COUNCIL ASSESSMENT REPORT

SYDNEY CENTRAL CITY PLANNING PANEL

PANEL REFERENCE & DA NUMBER	PPSSCC-417 – DA 1117/2023/JP
PROPOSAL	Demolition of Existing Structures and Construction of Residential Flat Building and Multi Dwelling Development comprising 177 dwellings under the Provisions of SEPP (Housing) 2021
ADDRESS	Lots 4, 5, 6, 7, 8, 9, 10, 11 DP 227212, Lots 30, 31, 32 DP 259208 1-6 Vivien Place, 1-7 Gay Street and 12 Gilham Street, Castle Hill
APPLICANT	Minto Planning Services
OWNER	P Song, K Song, Castle 7 Pty Ltd, J E Steffel, Castle 18 Pty Ltd, D M McLennan, G M McLennan, J W Maxwell, J J Maxwell, S S Lee, H Choi, J E C Nelis, S Nelis-Rocque, A Bhattacharya, S Bhattacharya, W S Yeung
DA LODGEMENT DATE	12 January 2023
APPLICATION TYPE	Development Application
REGIONALLY SIGNIFICANT CRITERIA	Clauses 2 and 5, Schedule 6 of the SEPP (Planning Systems) 2021
CIV	\$72,370,137 (excluding GST)
CLAUSE 4.6 REQUESTS	No Clause 4.6 variation provided.
KEY SEPP/LEP	- State Environmental Planning Policy (Housing) 2021 - State Environmental Planning Policy No. 65 – Design Quality of Residential Apartment Development - The Hills Local Environmental Plan 2019 - The Hills Development Control Plan

Figure 14 Castle Hill North Structure Plan

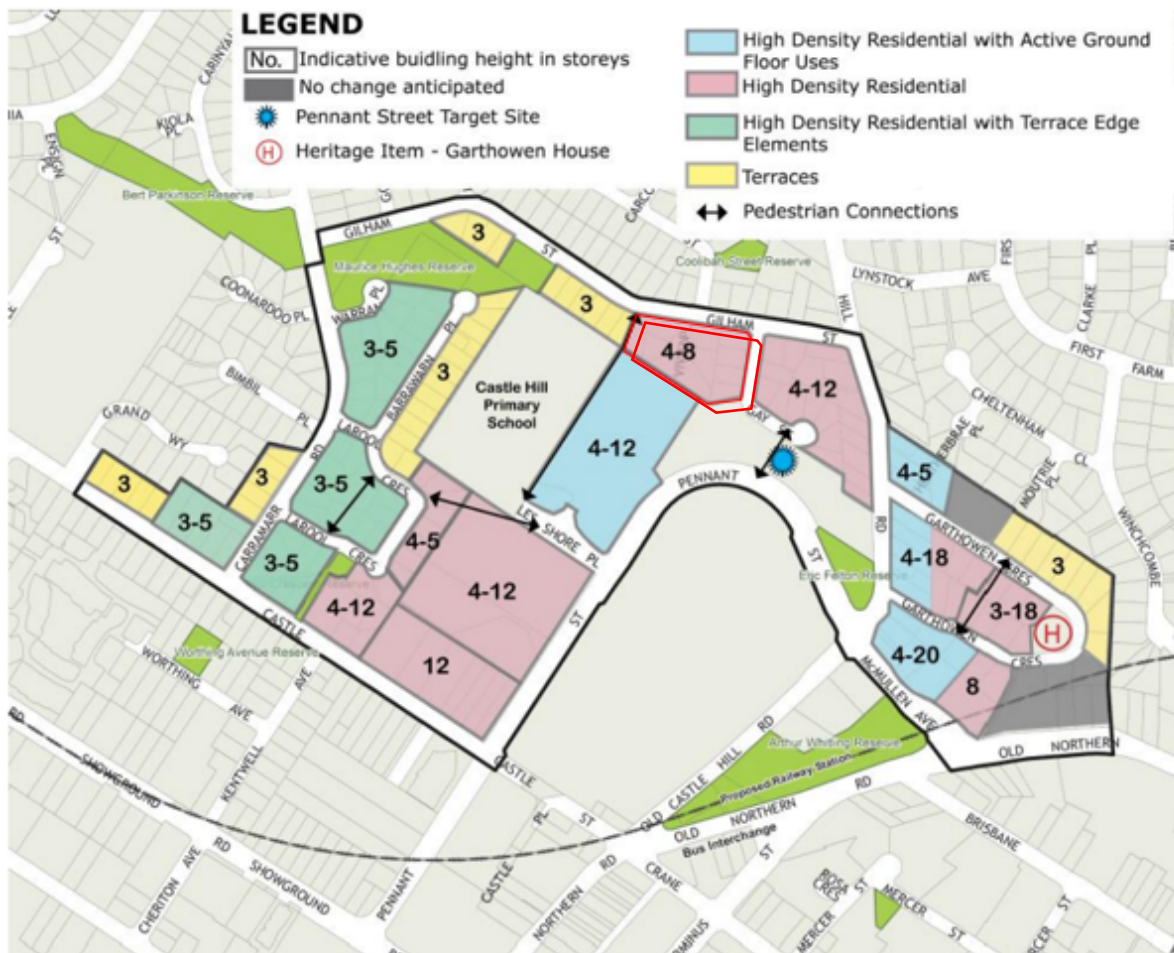
Buildings B and C do not comply with Section 3.2 Structure Plan and Key Elements of Part D Section 20 Castle Hill North Precinct of The Hills DCP which envisages development on this site to be between 4-8 storeys in height (refer figure 5 below). Building B is 11 storeys and Building C is 16 storeys which significantly exceeds the desired further character envisaged for this part of the precinct. Variations to this control can be contemplated, if a development demonstrates how the vision, development principles, key elements for the Precinct and relevant specific objectives are to be achieved. This has not been done by the Applicant.

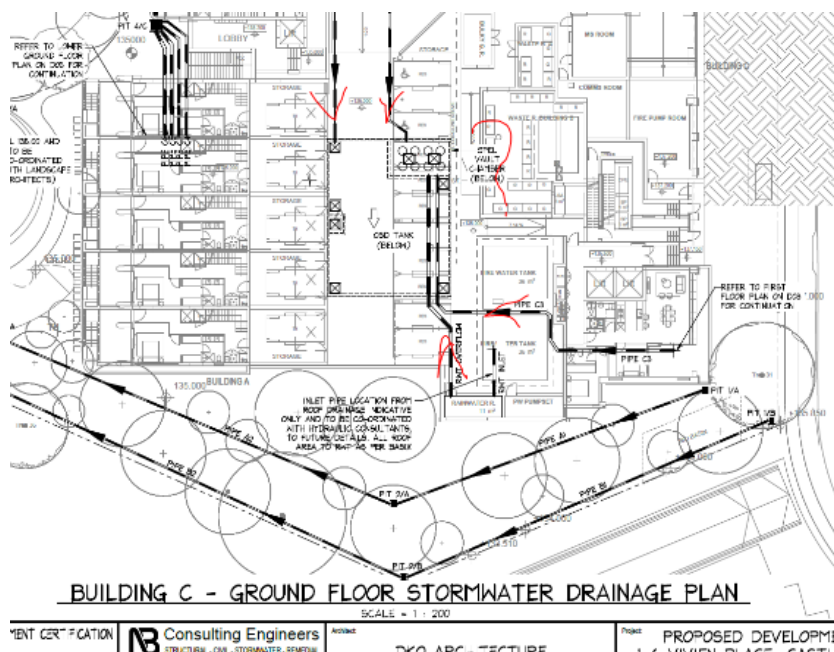
Filling the rear of Lot 11 DP 227212 to drain the development to Gilham Street will not be supported. The natural surface levels cannot be filled for the purpose of drainage. Similarly,

the lots facing Gay Street are sloping to the rear but the applicant's engineer is proposing to cross-catchment and drain the site to Gilham street, which is not supported.

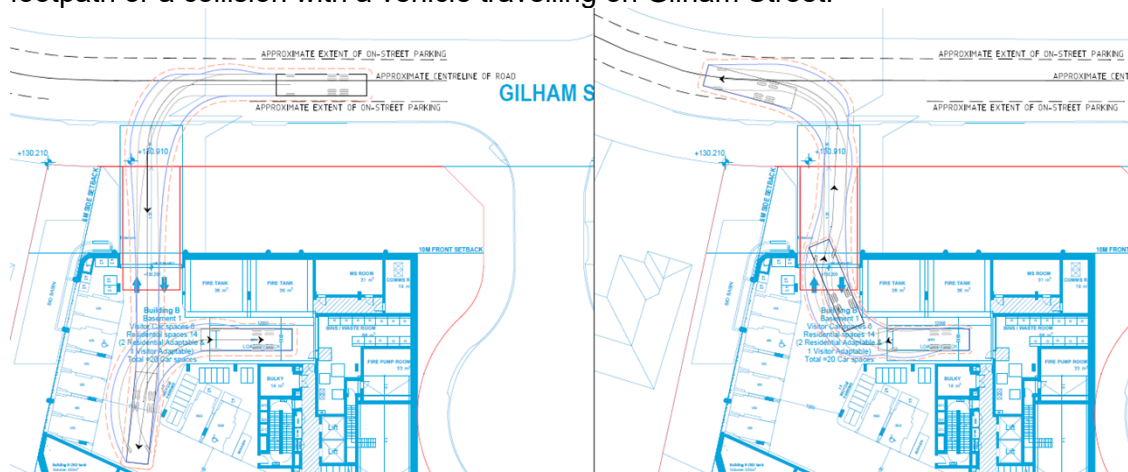
There is no information to show that the gradient and the rate of grade change for the ramp of the basement does comply with AS2890.2 for the MRV that accesses the basement.

The MRV is occupying the full width of the internal driveway/circulation roadway which is not supported. Refer to the snapshot below. Should an ingress vehicle meet an ingress MRV on the driveway, the ingress vehicle will be forced to reverse uphill, and onto the adjacent footpath and Gilham Street, thus significantly increasing the chance of striking a pedestrian on the footpath or a collision with a vehicle travelling on Gilham Street.

If the MRV is to occupy the whole width of the driveway, the Applicant must demonstrate how the proposed development will manage the conflict between the MRV and B99. Passing bays must be provided within the site's boundary not the vehicular crossing. Queuing on the street will not be supported.

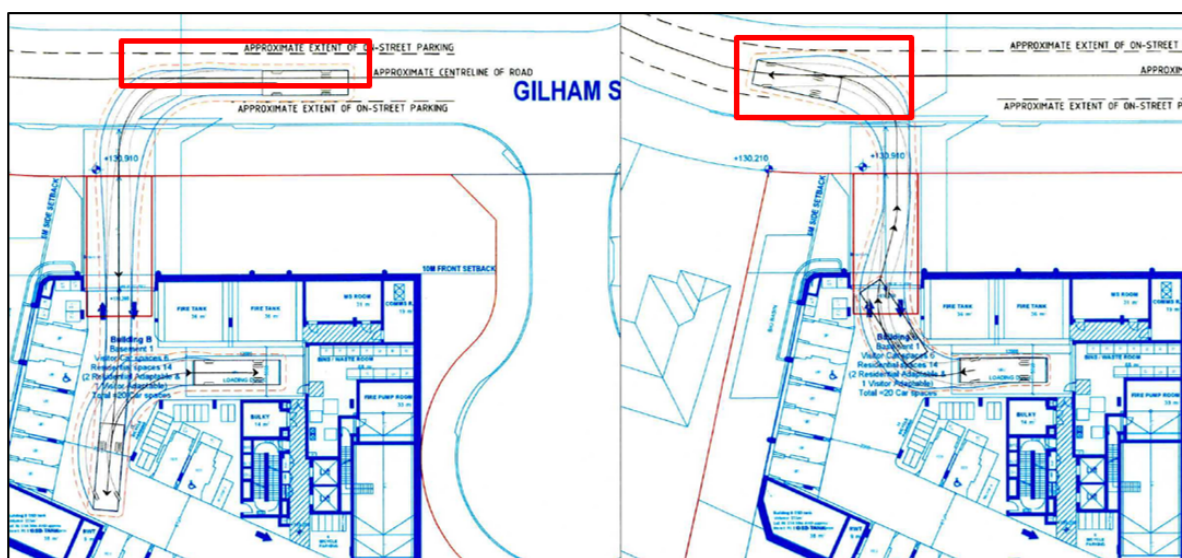
The swept path analysis shows that service vehicles would not be able to enter and leave the access driveway without being forced to cross the centre-line to the extent that there is interaction with the opposing direction of travel, thus increasing the chance for crossing turning or head-on collisions to occur on Gilham Street (refer to Figure below).

Swept turning paths demonstrating the required manoeuvring in order for longest vehicle to enter and leave the site in a forward direction has not been provided. The width of internal driveway/circulation roadway must be designed to facilitate expected longest vehicle type and a B99 car pass each other simultaneously (i.e. maintaining two-way traffic flow).

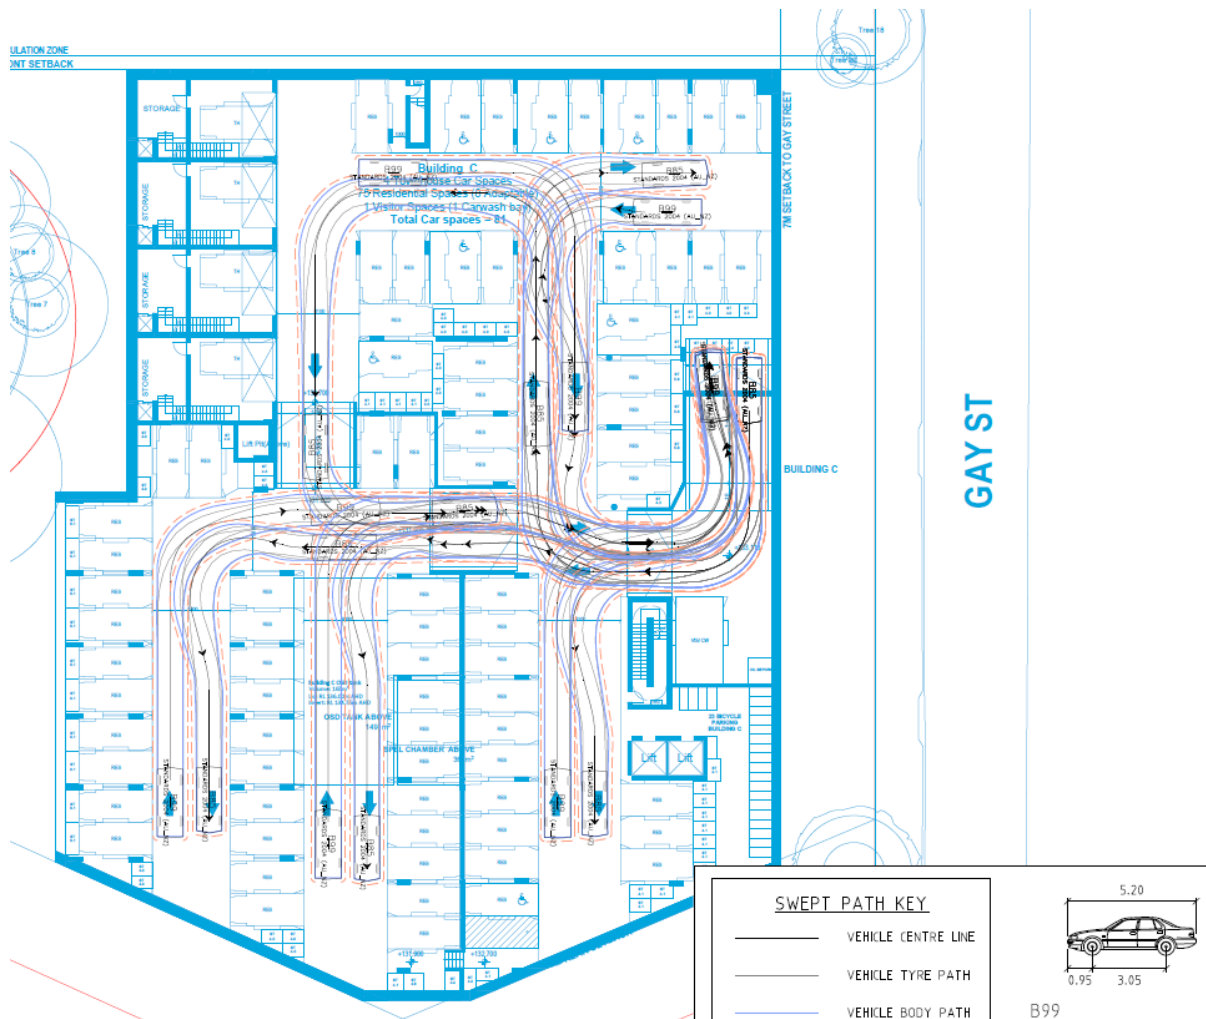
The provided swept pathways are not legible. Refer to the snapshot below. A revised swept turning paths for Building C on separate pages must be provided.
